Site Plan Review Committee (SPRC)
Staff Report for
1600 S Eads – Crystal Towers 3

Crystal Towers 3 (SPLA22-00018)
1600 S. Eads
(RPC#s 35-011-010, -011)

Figure 7: Proposed Site Circulation

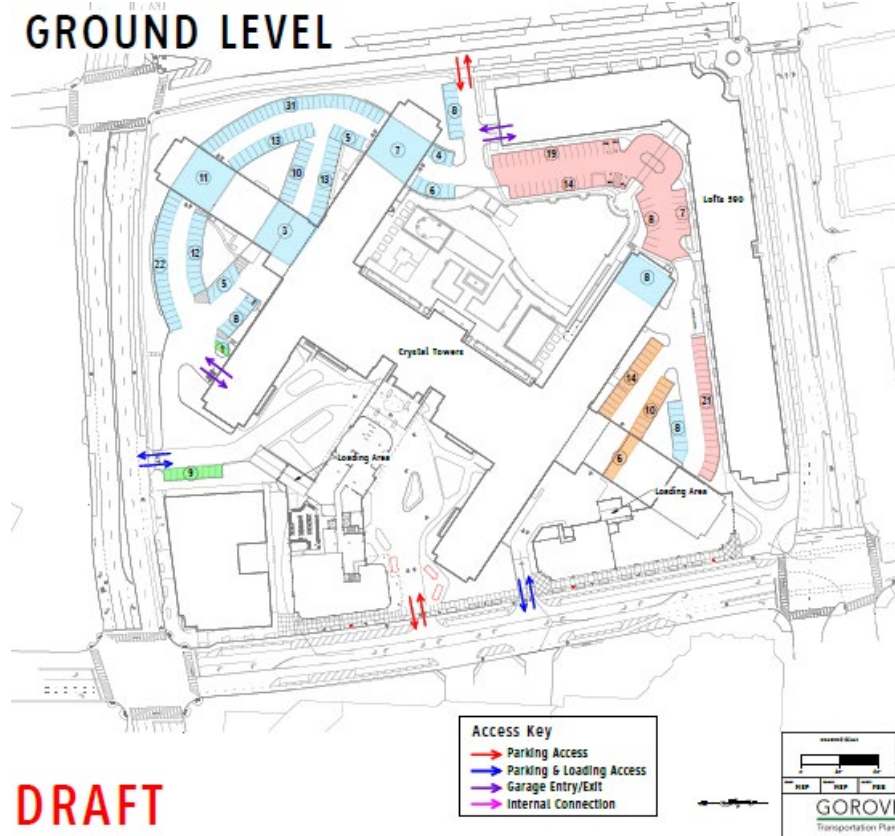
The proposed retail building will tie into an existing residential building at the ground floor level and will extend out to front along S. Eads Street. In the proposed plan, there will be two curb cuts on S. Eads Street (See Figure 7 below). The curb cut most adjacent to the proposed residential building would provide internal site access and could exit on 18th Street. The curb cut adjacent to the retail building provides access to limited parking and the loading area for retail.

Figure 8: Building Height's Map – Crystal City Sector Plan

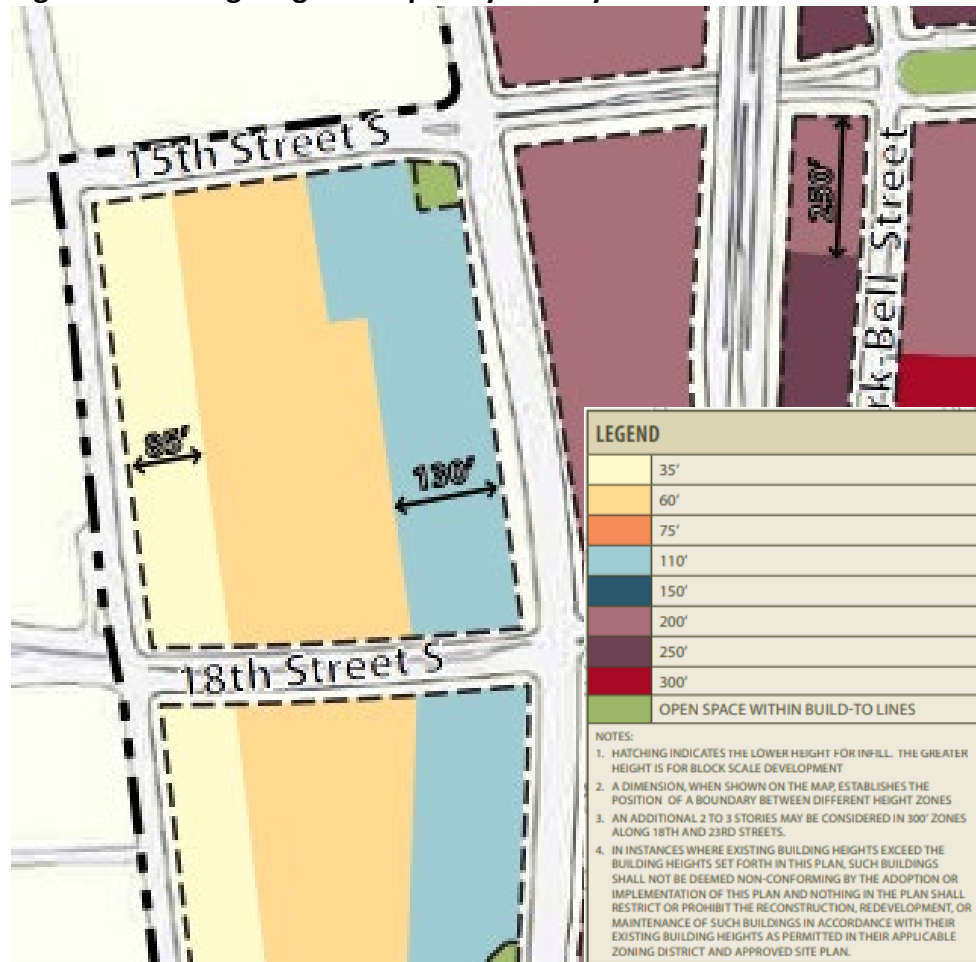
Building Height: The applicant is proposing a building height of approximately 132' for the residential building. The underlying zoning district of RA4.8 allows for a building height of 136' from average site elevation to the top of the building penthouse. The Crystal City Sector Plan provides guidance for a 110' building height on this site, tapering down to 60' and then eventually 35' (see figure 8). The Sector Plan's guidance is codified in the C-O-Crystal City zoning district, however, the applicant is not requesting a rezoning, so is not subject to the C-O-Crystal City building height. Staff continues to analyze this deviation from the Sector Plan to determine if it is acceptable at this location.

- **Maximum Allowable Height:** As noted above, the combined height of the podium and tower for development of the subject site should not exceed 110 feet and should taper down to 60' internal to the block and then 35' along S. Fern Street. As discussed above, the proposed residential building is not consistent this guidance.

Figure 9: Crystal City Sector Plan Design Buildable Envelope and Massing Strategies

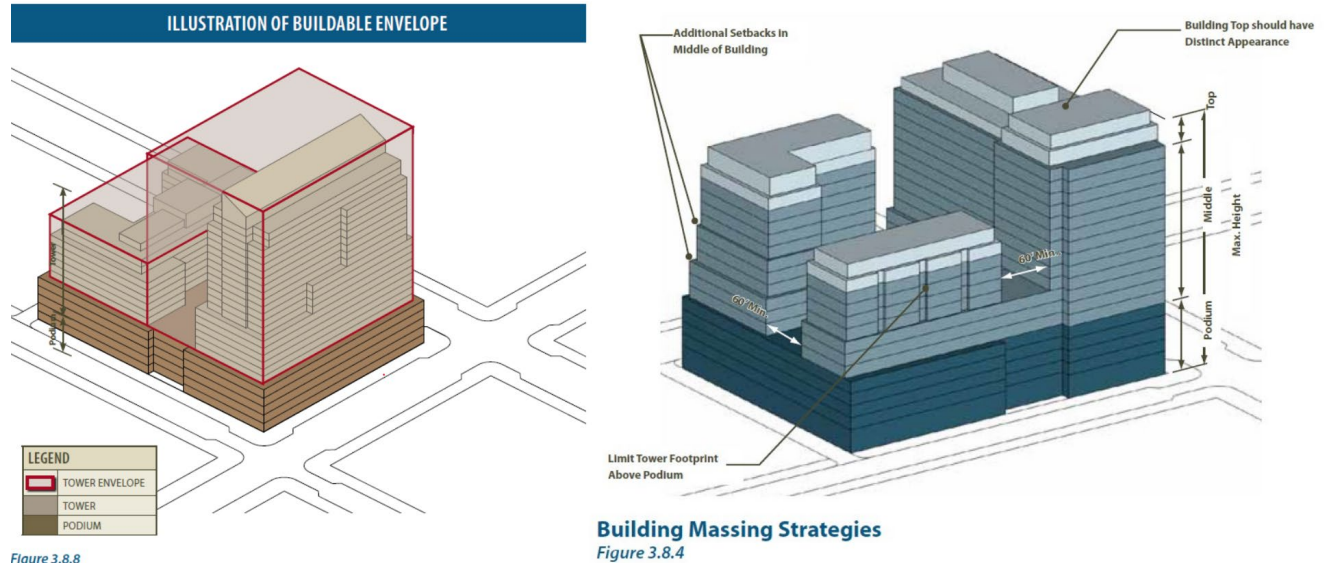
Building Form, and Architecture: Section 3.11 of the Crystal City Sector Plan provides Design Guidelines for use as reference in the redevelopment of Crystal City. These guidelines contemplate redevelopment buildings for full blocks, and not necessarily the in-fill type buildings that the applicant is proposing. These guidelines recommend that all new and substantially renovated buildings incorporate a design scheme that provides a distinct podium, middle and top. As defined by the Crystal City Sector Plan, the podium consists of the lower five (5) to six (6) stories (or less) of the building, while the remaining stories consist of the middle and top elements that comprise the building's tower. The middle consists of those stories above the podium, but excluding the top elements that are defined as the upper two (2) to four (4) stories. The guidelines "are intended to be flexible" and many are "aimed at allowing adequate sunlight to reach public streets and open spaces, as well as achieving a level of architectural interest, articulation, and sculpting currently lacking in Crystal City." These guidelines achieve multiple goals, including: regulating achievable densities; realizing pedestrian-oriented design of new development; creating a visually interesting skyline; and ensuring adequate sunlight for public spaces. The proposed residential building has a podium that consist of the first four stories and the proposed retail building is a single-story building

- o Building Setback Profiles: The Sector Plan recommends two (2) approaches for achieving sculpted buildings with distinct podiums, towers, and tops – a Multiple Setback Approach, and a Single Setback Approach. While the podium should continuously engage the Build-to Line and meet the back of the sidewalk, the tower massing above should taper or step back from the podium along streets and open spaces to achieve aesthetically interesting and attractive buildings, and to allow for light and air between buildings. For building tops, it is generally recommended that the upper two (2) to four (4) floors of all buildings should be no closer than 20 feet from the Build-to Line, unless the proposed design of the building top involves a dramatically creative architectural treatment that is integral to the overall composition of the building. The step-back approach for the proposed residential building and staff will continue to evaluate whether these deviations detract from the overall Sector Plan objectives.
